X3T9.2/87-168

N 429
ISO/TC97/SC13(JAPAN)
September, 1987

Some proposals of SCSI-2
(from Japanese Host-Adapter implementers)

(fig.1)

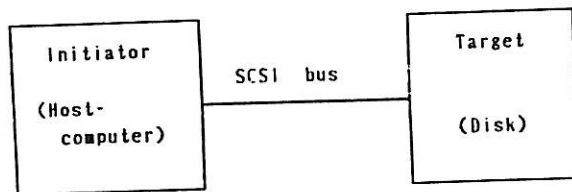
The initiator sends a READ COMMAND to the target (see fig.1)
After the Command phase, the target performs the DISCONNECT procedure and it shall release the SCSI soon.

If the initiator desires to cease this command during this term, it shall select the target again, then send the ABORT message.

Is this message valid? This procedure is not defined in the SCSI standard.
